**ARCHITECTURAL REVIEW BOARD  
MUNICIPAL PLANNING COMMISSION  
-AGENDA-  
Thursday, June 25, 2026 at 7:00 P.M.**

SUBJECT: Staff Memo for the Meeting of June 25, 2026

**1. Rezoning – PUD Preliminary Plan – 445 E. Granville Rd. (Elford Development/ Boundless)  
PUD 01-2026**

**EXISTING CONDITIONS**

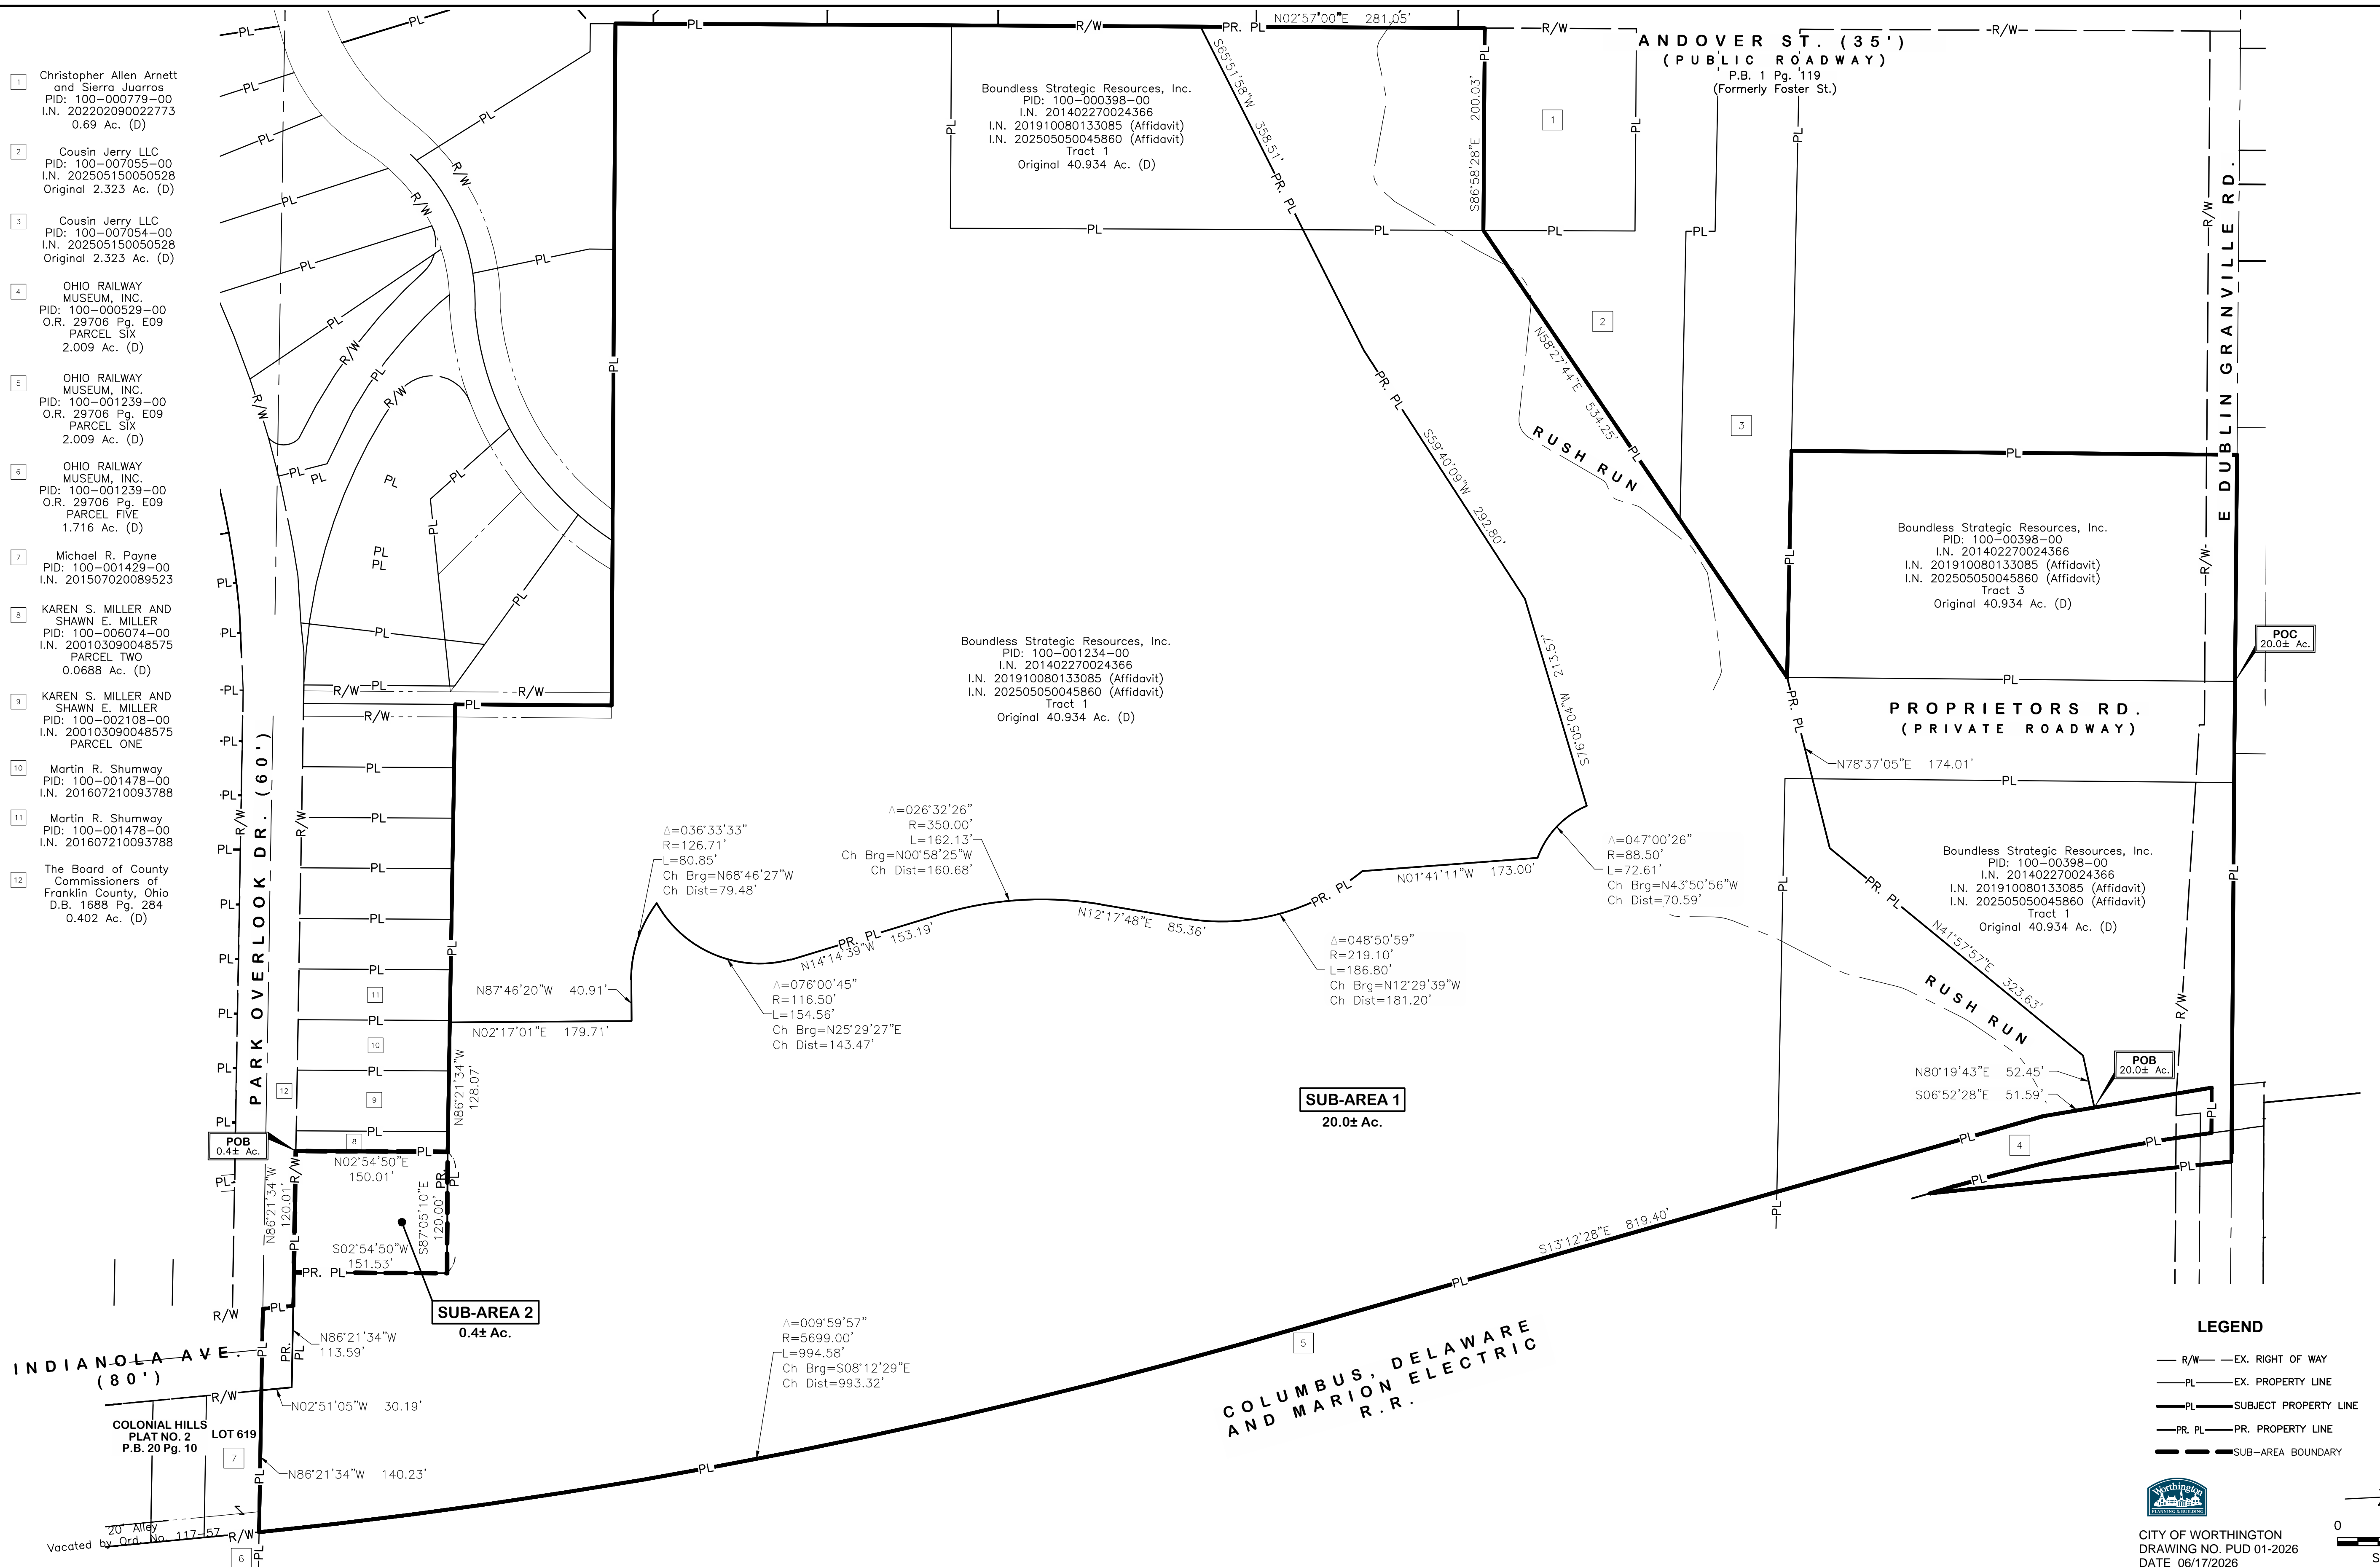
- a. Owners, developers, surveyors, engineers and architects have been identified.
  - b. Date, north arrow and site acreage are shown.
  - c. Existing Conditions (page 27 of 58) – Four buildings are planned for removal

**SITE LAYOUT PLAN**

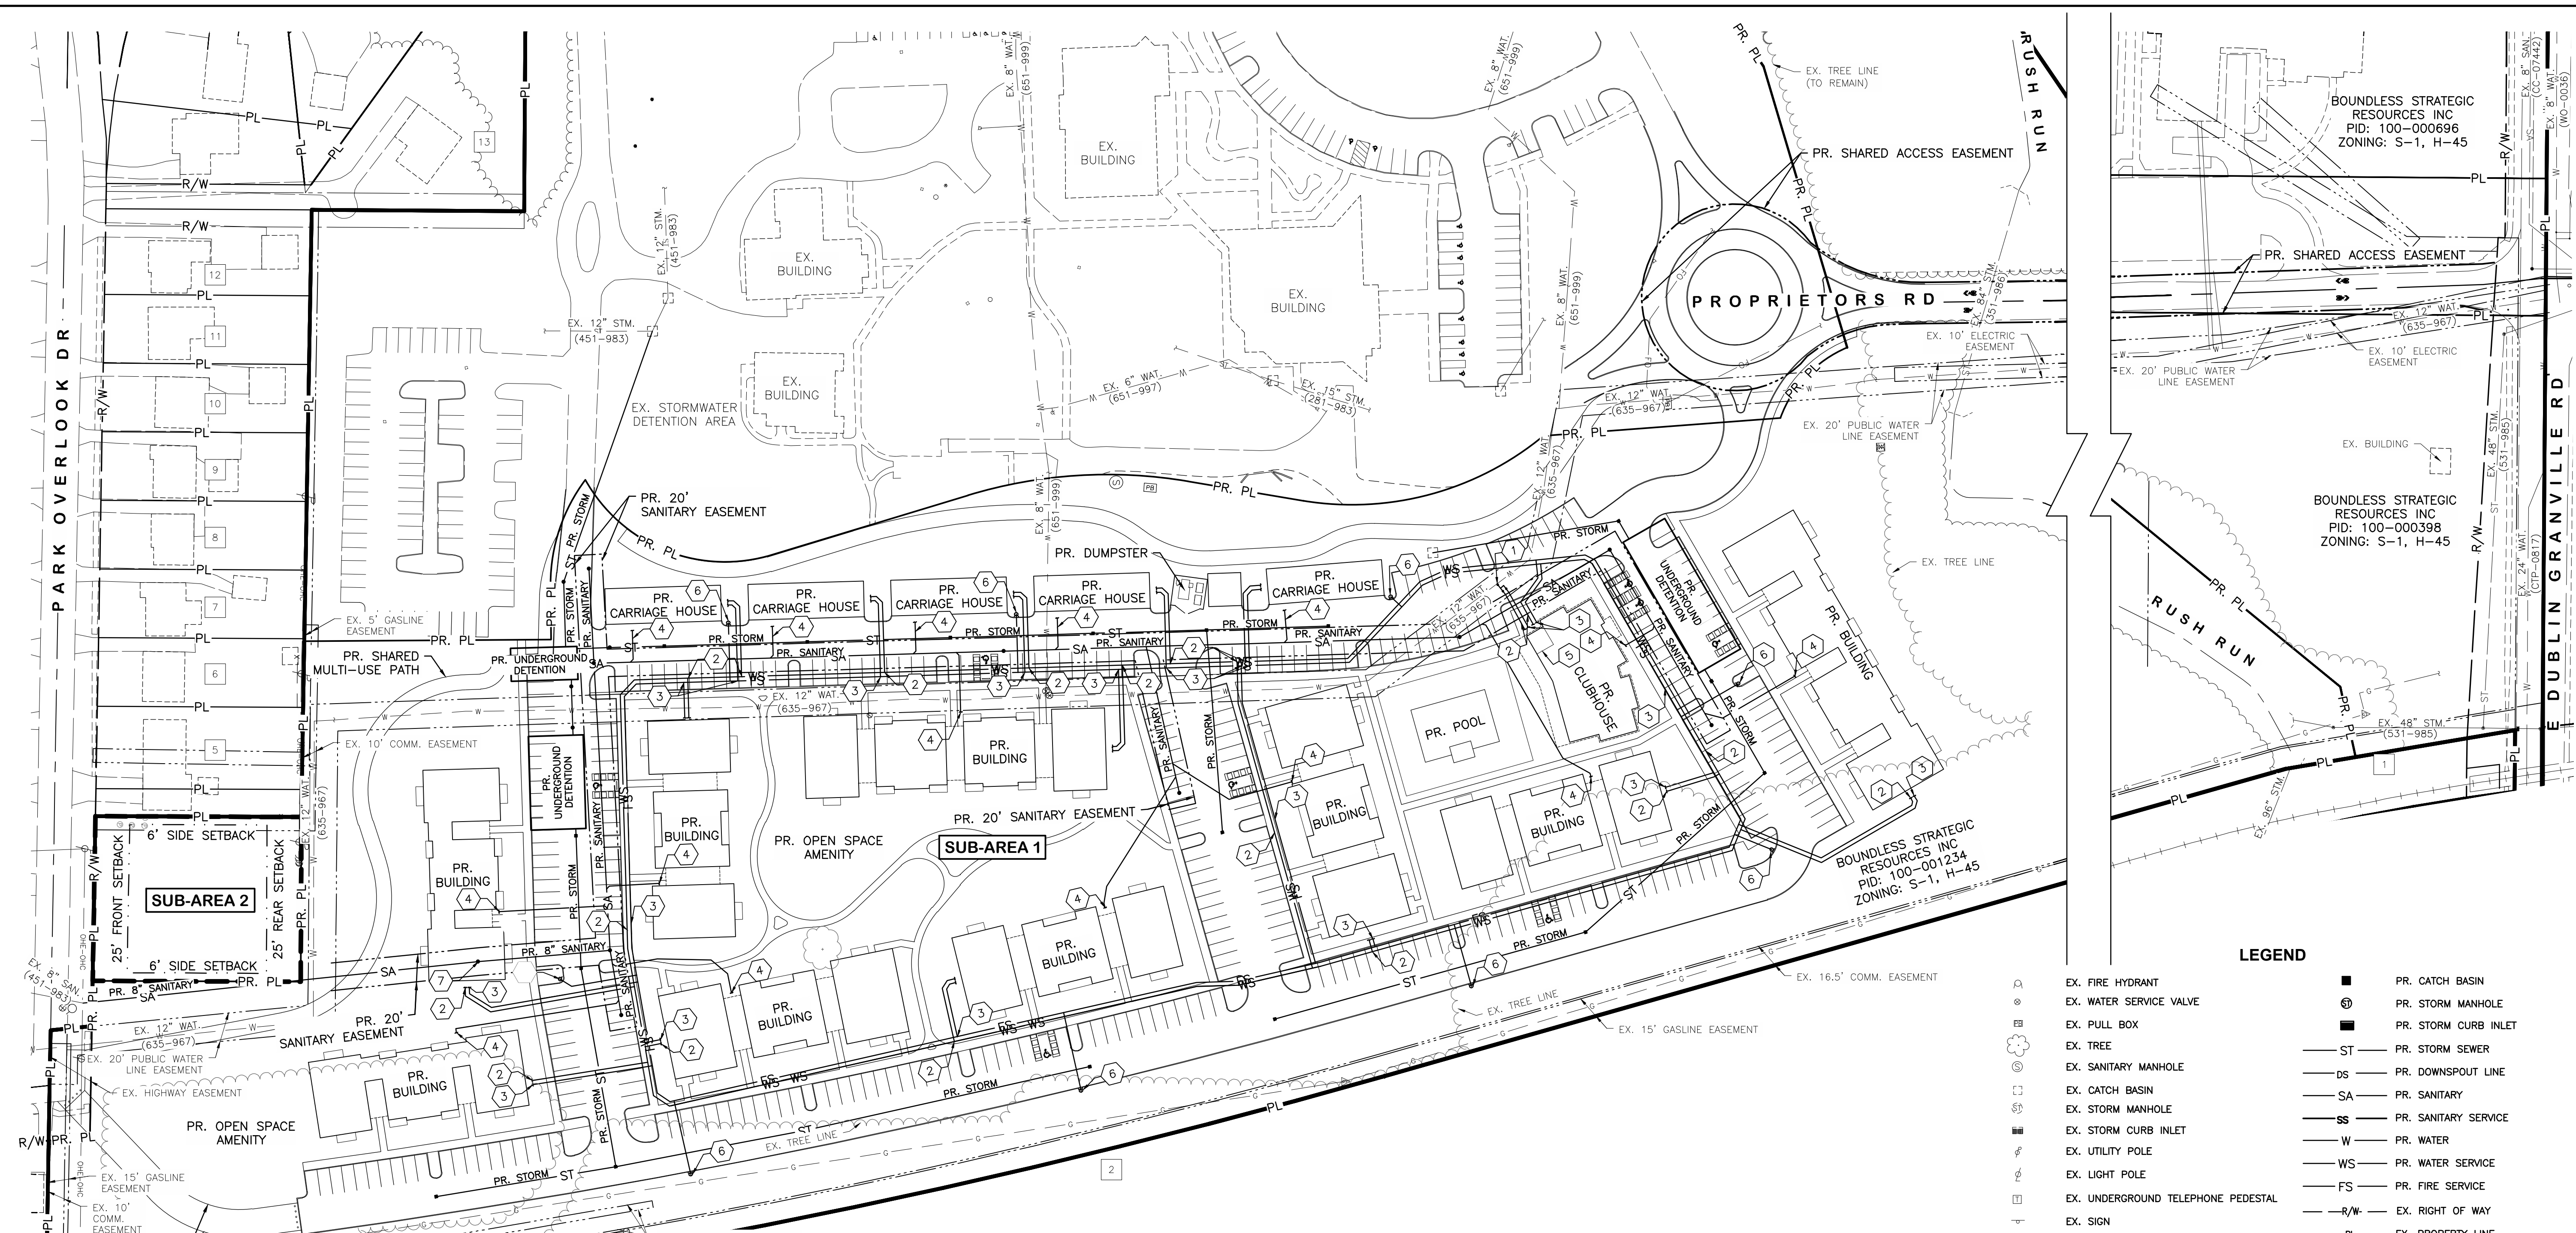
- d. Preliminary Grading Plan (page 31 of 58)
  - e. Site Layout Plan (page 29 of 58)
  - f. Site Utility Plan (page 30 of 58)
  - g. Dwelling Units/Acre:  
246 multi-family + 2 single-family = 248 units ÷ 20.4 acres = 12.2 units/acre
